Version 2

Front and/or Rear Brakes Squeal When Applied at Low Speeds

Supersedes 19-053, dated October 29, 2019, to revise the sections highlighted in **yellow**

Front Brake Disc Replacement

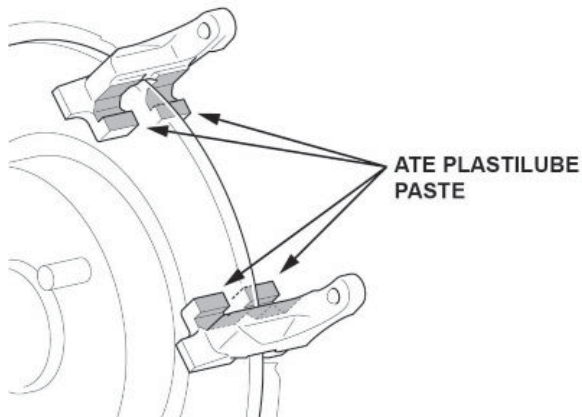
The 2019-20 RDX is equipped with FNC brake discs. These brake discs cannot be machined or refinished.

1. Replace the front brake discs. Refer to the service information.
2. Make sure the brakes are cooled down, then test-drive the vehicle multiple times to make sure the squeal is gone. If the brakes still squeal, check the inspection procedure to see if the rear brake squeal symptoms apply.
